# ADDENDUM NO. 1

**April 29, 2022**

**NEW ADMINISTRATION CENTER, ALTERNATE EDUCATION AND  
RESOURCE CENTER AND RELATED WORK PROJECT  
Crown Point, IN 46307**

This Addendum forms a part of and modifies the Bidding Requirements, Contract Forms, Contract Conditions, the Specifications, and the Drawings dated April 15, 2022 by Gibraltar Design. Acknowledge receipt of the Addendum in the space provided on the Bid Form. Failure to do so may subject the Bidder to disqualification.

**DRAWING**  
**PROPOSED SITE PLAN**

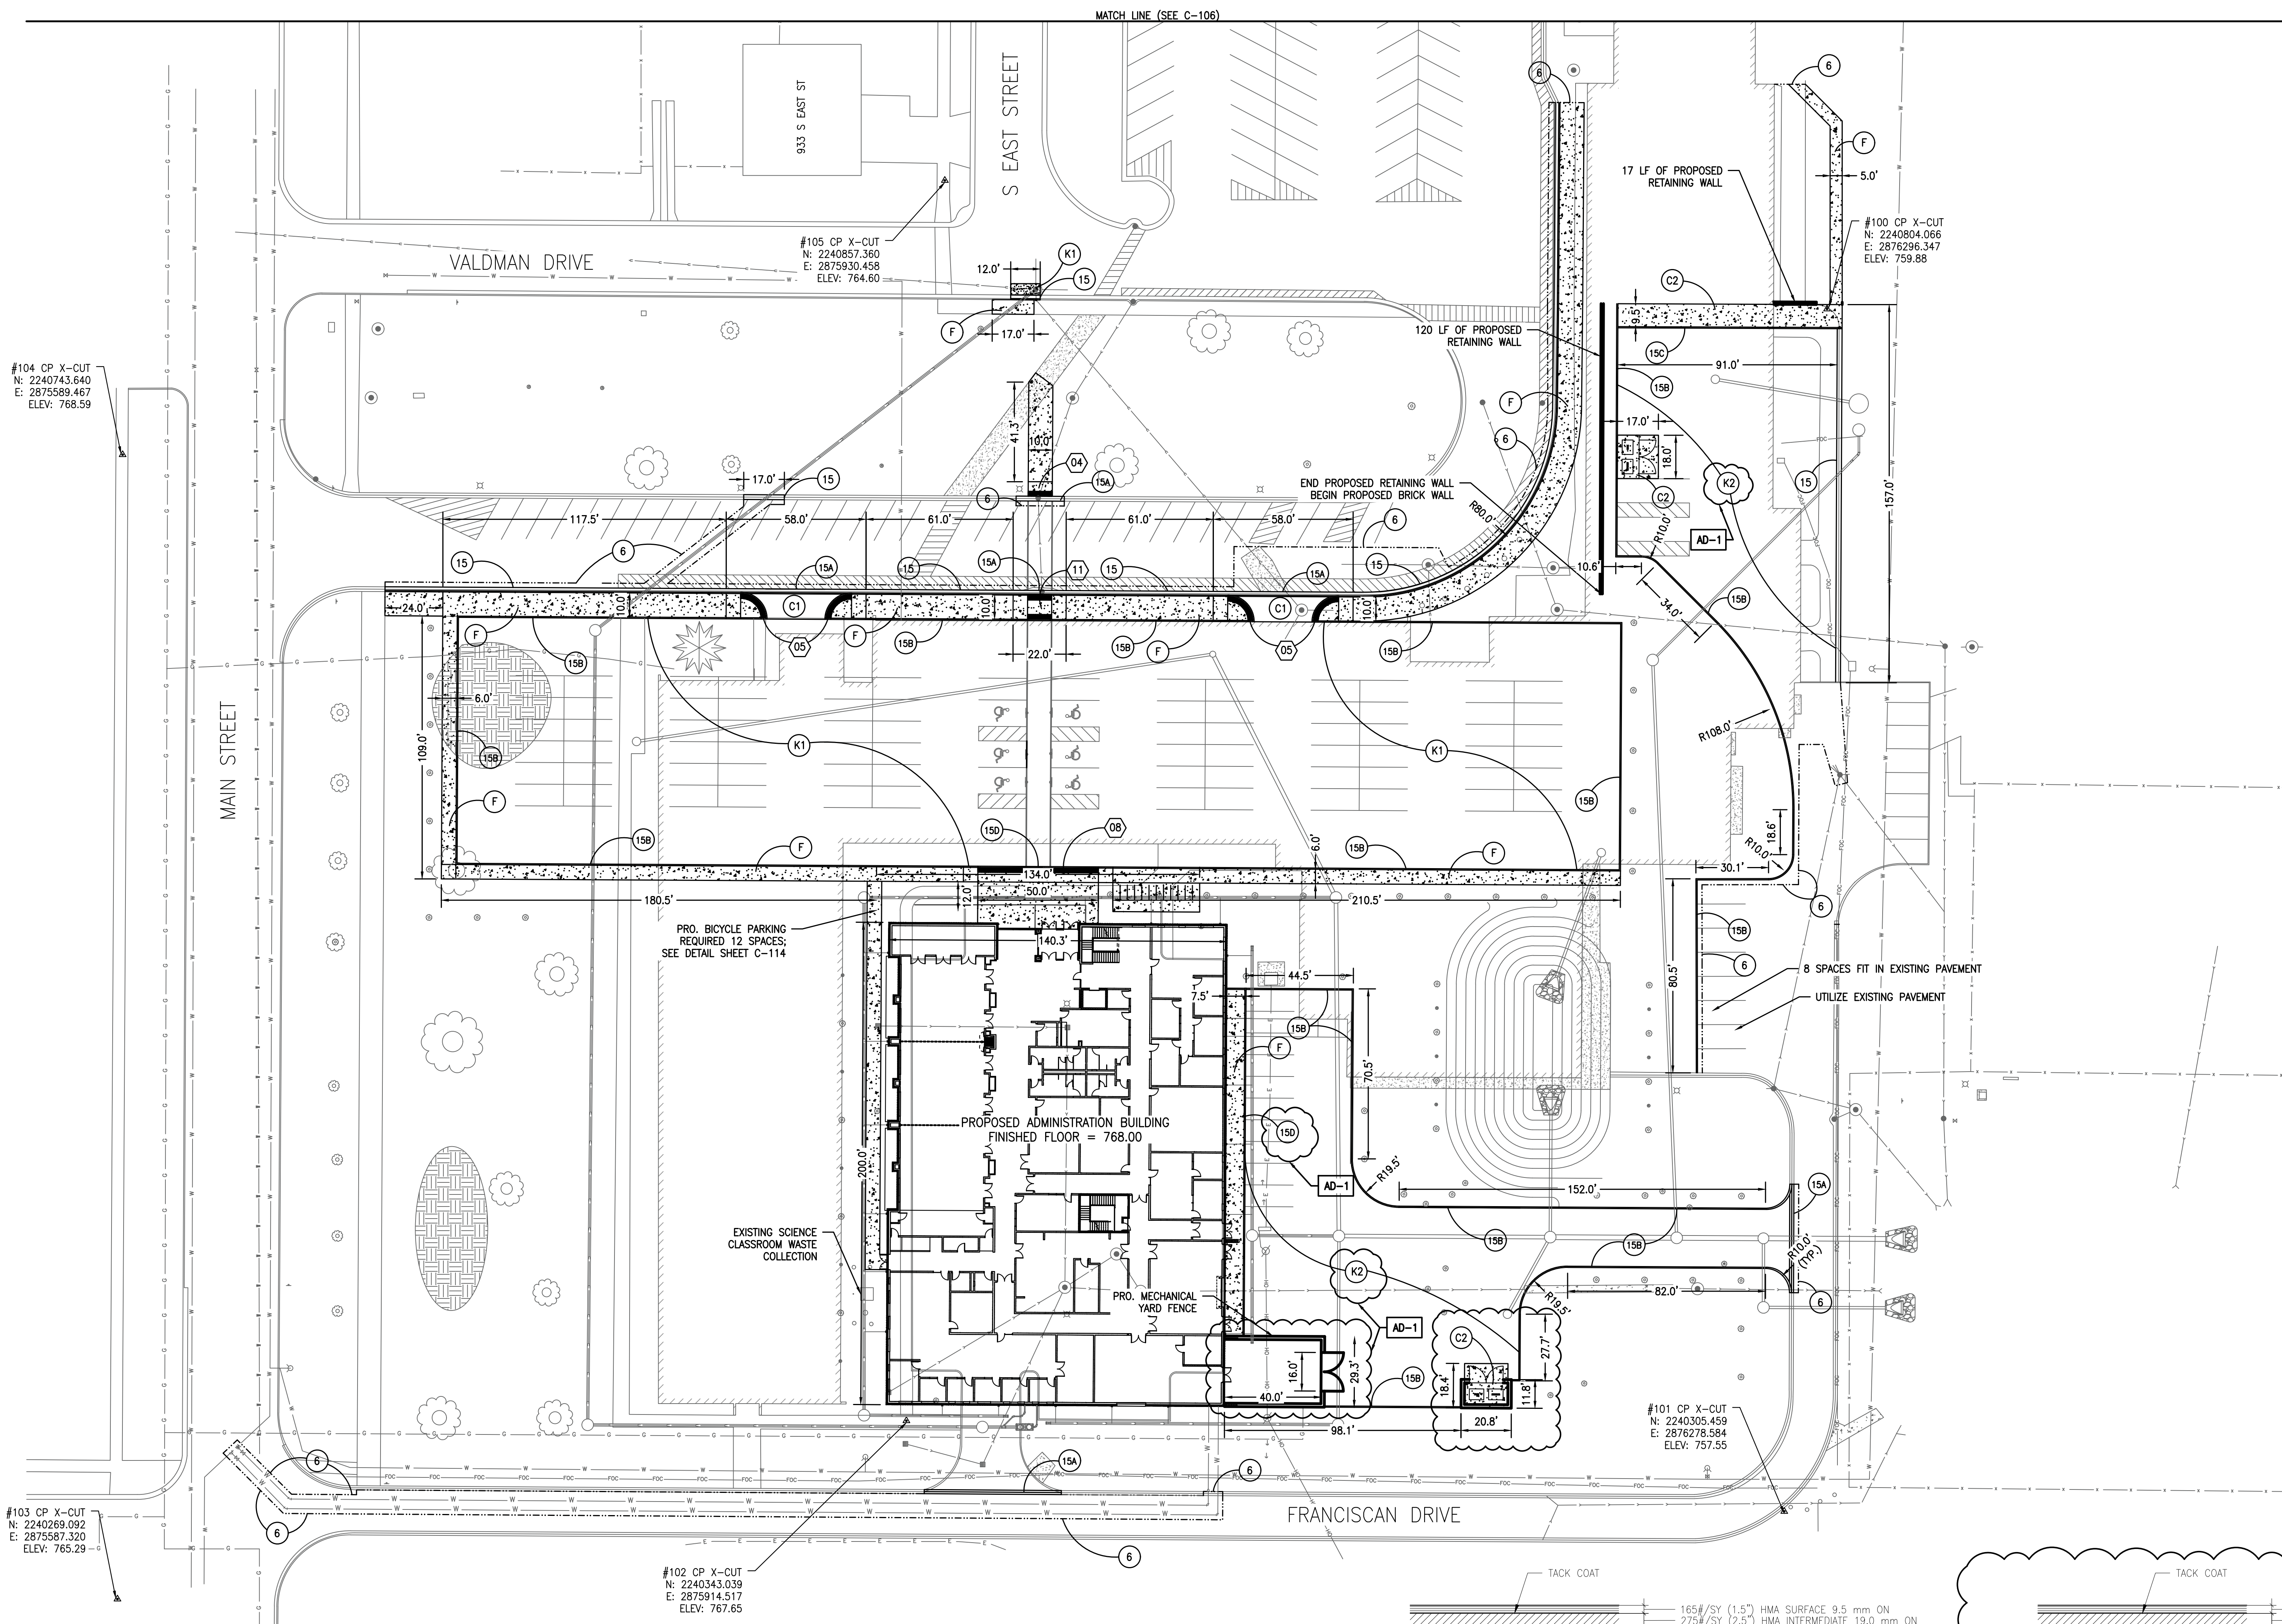
**2. Sheet C-105**

- A. Refer to revised, full size drawing, included in this Addendum, for the following revisions:
1. Add heavy duty pavement section detail.
  2. Revised proposed pavement at receiving lot and east administration parking lot to be heavy duty pavement.
  3. Revised barrier curb along sidewalk east of administration building to be depressed barrier curb.
  4. Revised dumpster enclosure area to include masonry enclosure with gate; revised curb along enclosure.
  5. Revised mechanical yard enclosure.

- ADDED HEAVY DUTY PAVEMENT SECTION DETAIL.
- REVISED PROPOSED PAVEMENT AT RECEIVING LOT AND EAST ADMINISTRATION LOT TO BE HEAVY DUTY PAVEMENT.
- REVISED BARRIER CURB ALONG SIDEWALK EAST OF ADMINISTRATION BUILDING TO BE DEPRESS BARRIER CURB.
- REVISED DUMPSTER ENCLOSURE AREA TO INCLUDE MASONRY ENCLOSURE WITH GATE, REVISED CURB ALONG ENCLOSURE.
- REVISED MECHANICAL YARD ENCLOSURE.

**DRAWING**  
**PROPOSED GRADING PLAN**  
**SOUTH SECTION**

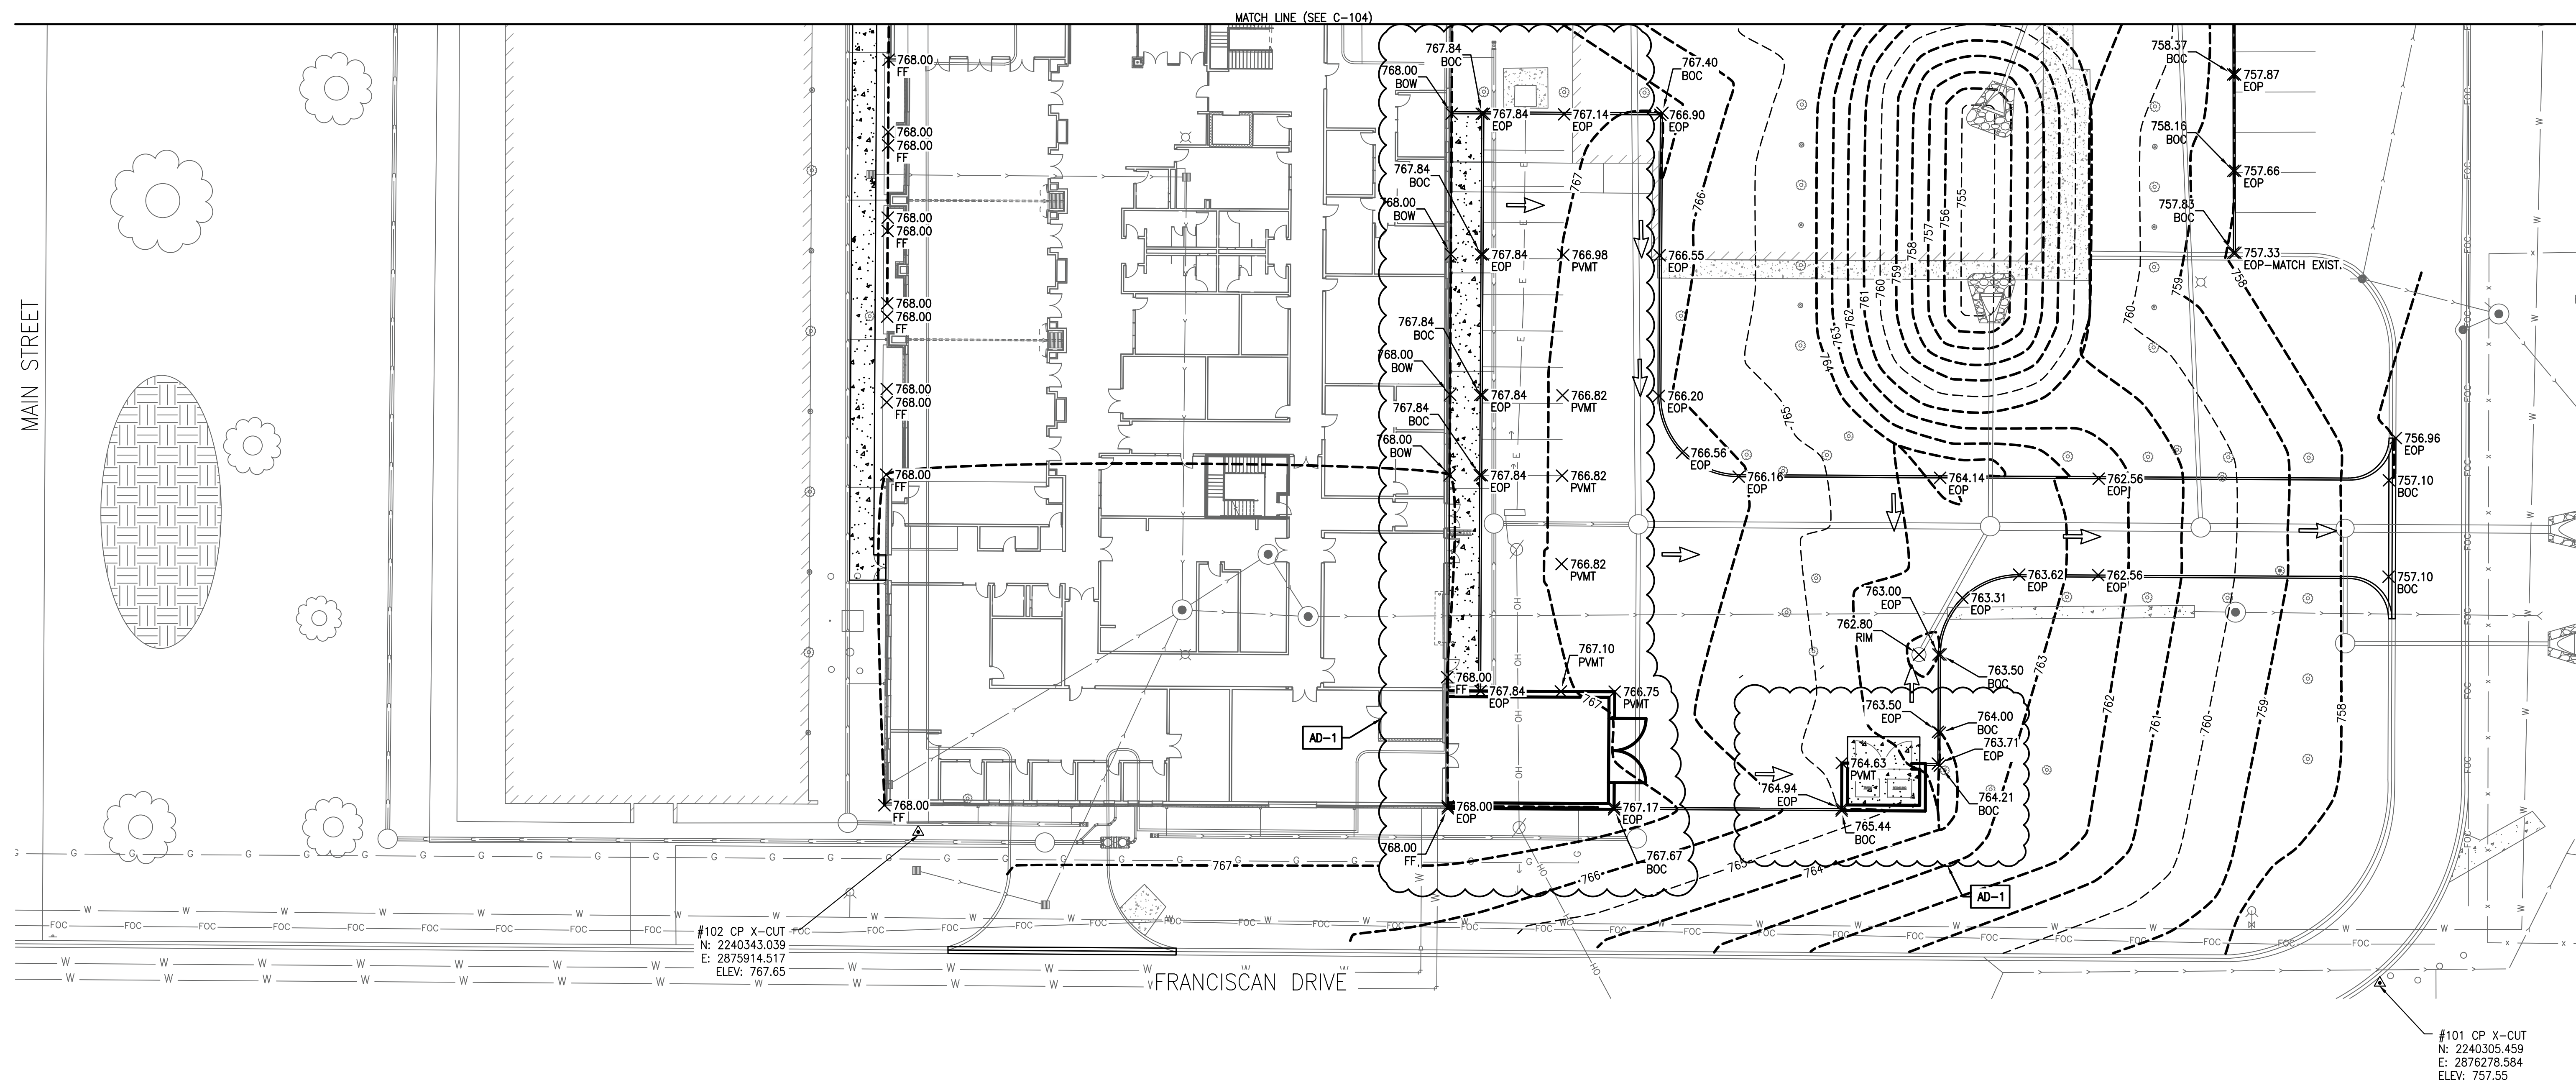
**3. Sheet C-108**

- A. Refer to revised, full size drawing, included in this Addendum, for the following revisions:
1. Administration Building East Lot: Revised west edge of pavement to be flush with proposed sidewalk grade.
  2. Revised grading around trash enclosure.

1. ADMINISTRATION BUILDING EAST LOT: REVISED WEST EDGE OF PAVEMENT TO BE FLUSH WITH PROPOSED SIDEWALK GRADE.
2. REVISED GRADING NEAR TRASH ENCLOSURE

**DRAWING**  
**PROPOSED LANDSCAPE,  
STRIPING, AND SIGNAGE  
PLAN**

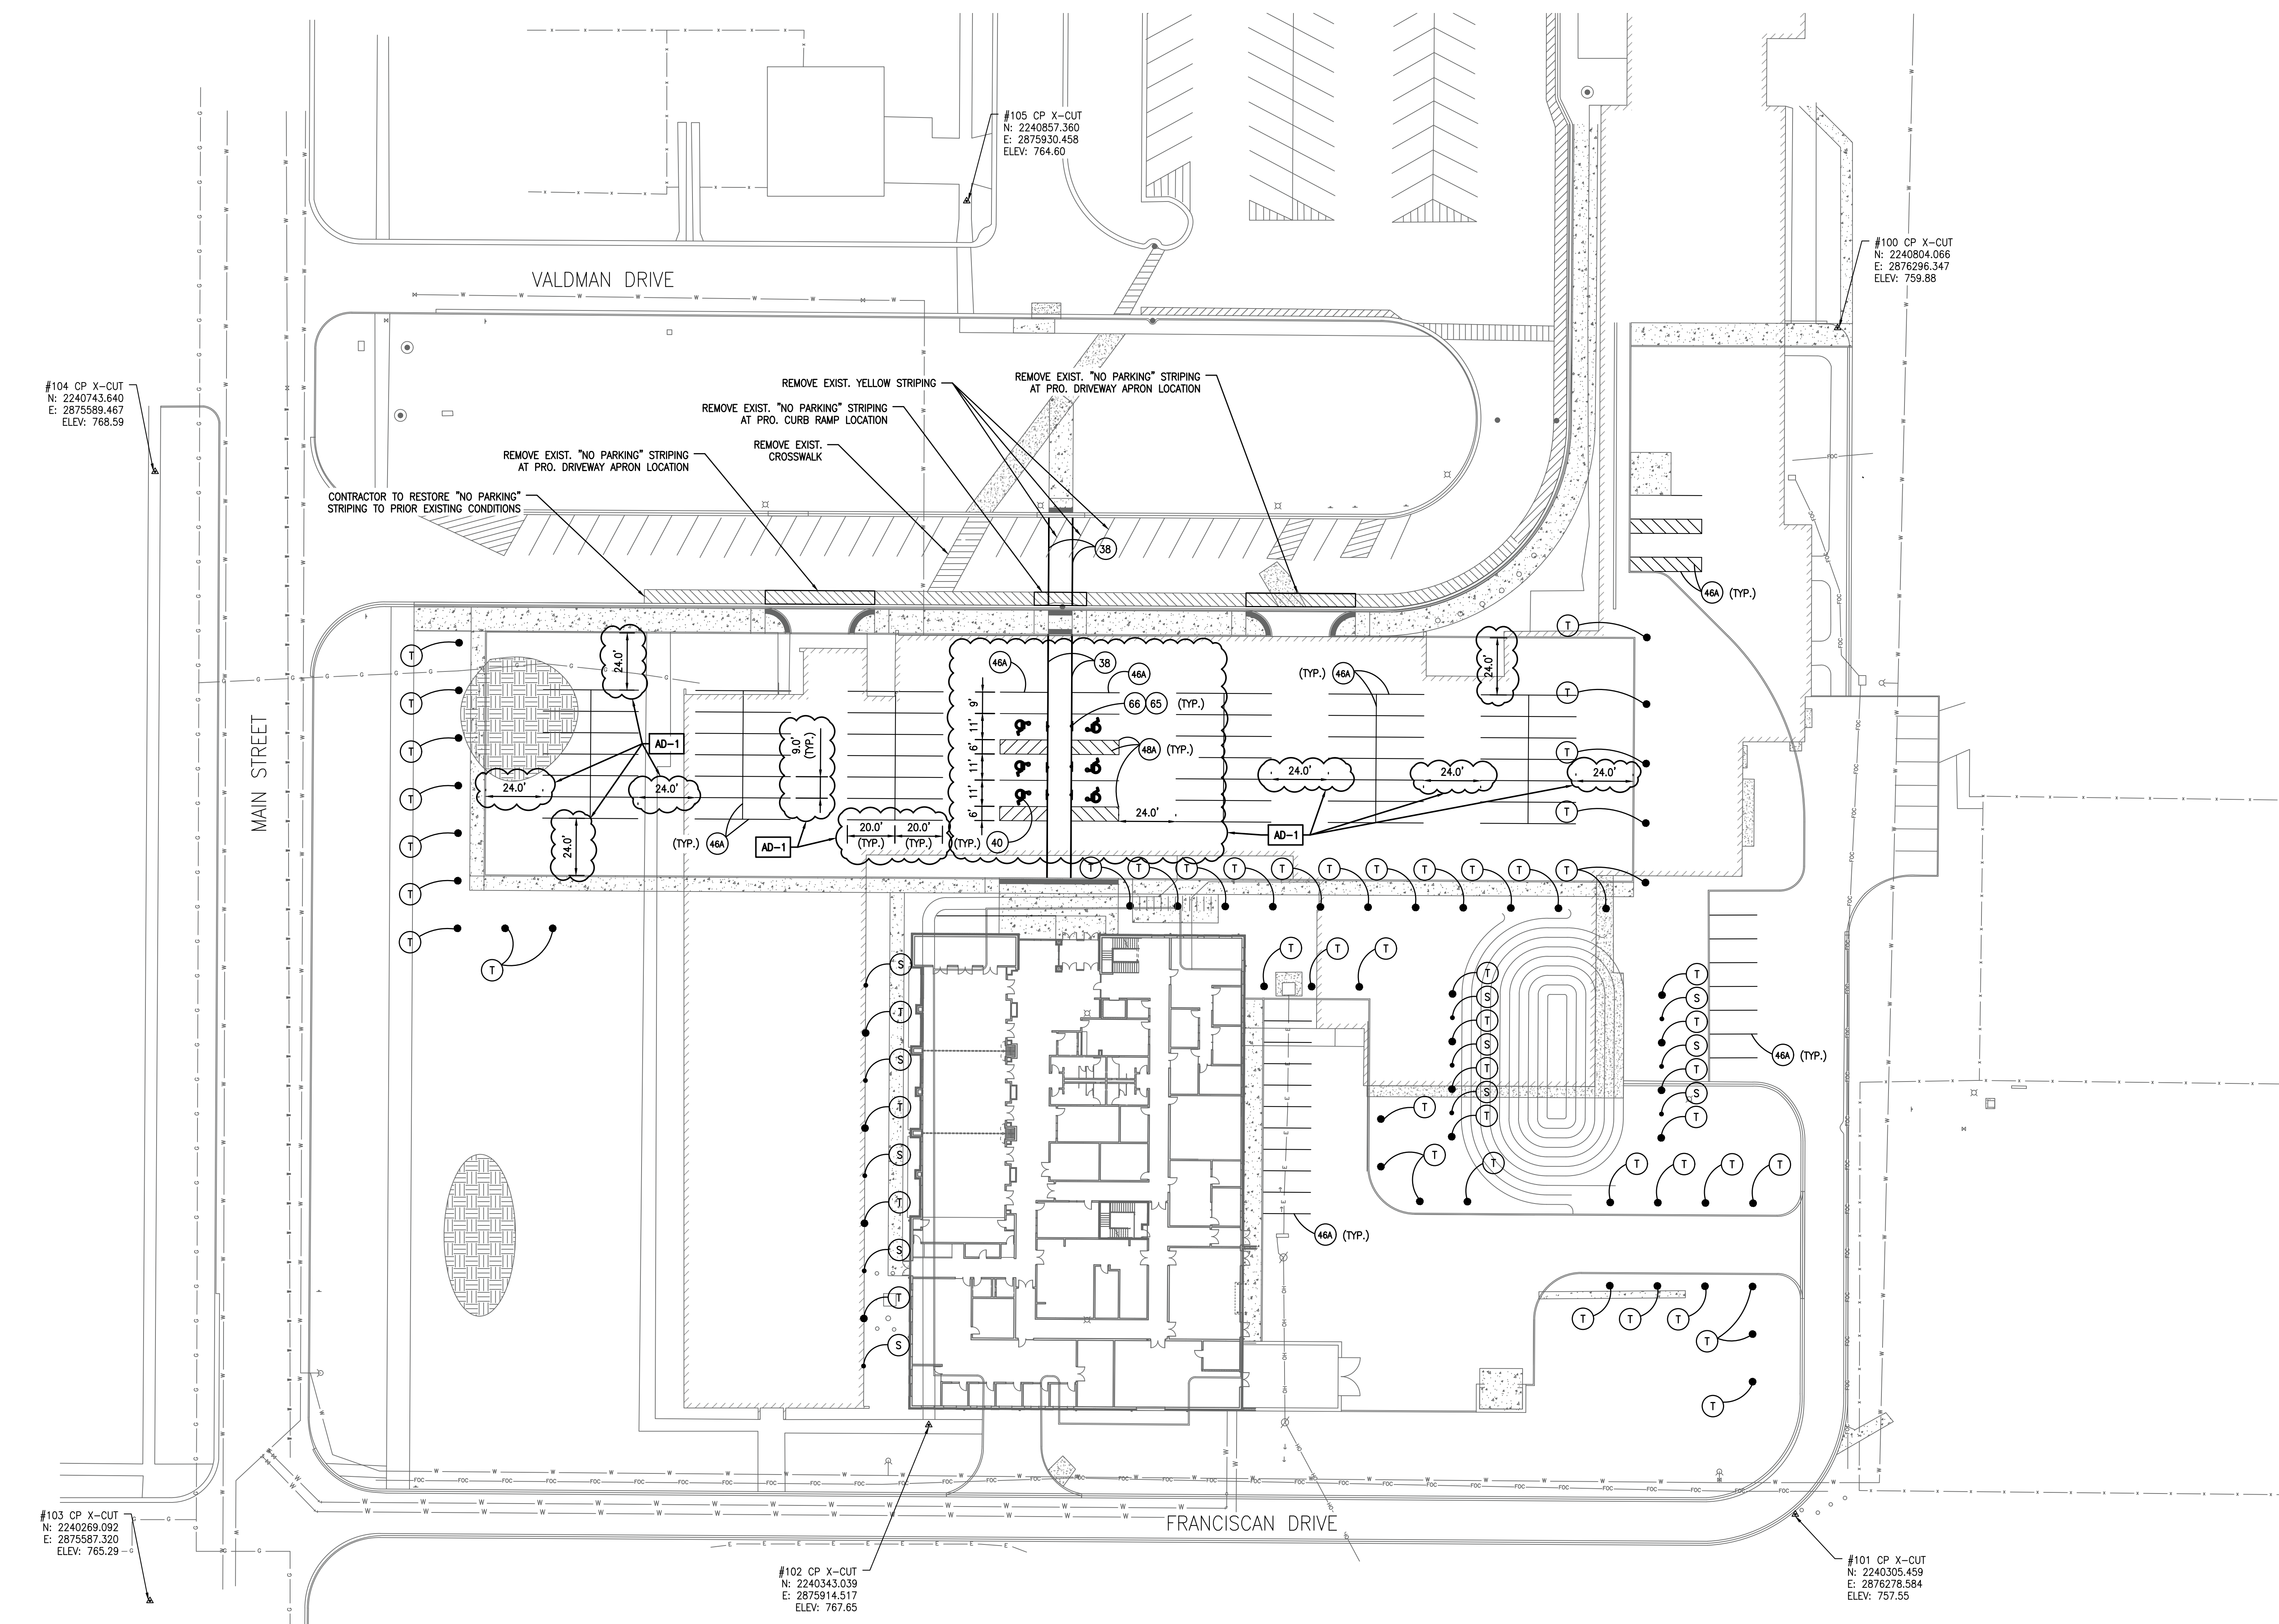
**4. Sheet C-111**

- A. Refer to revised, full size drawing, included in this Addendum, for the following revisions:
1. Revised ADA Parking Layout.
  2. Added parking space typical dimensions.

- AD-1 REVISIONS:**
1. REVISED ADA PARKING LAYOUT
  2. ADDED PARKING SPACE TYPICAL DIMENSIONS
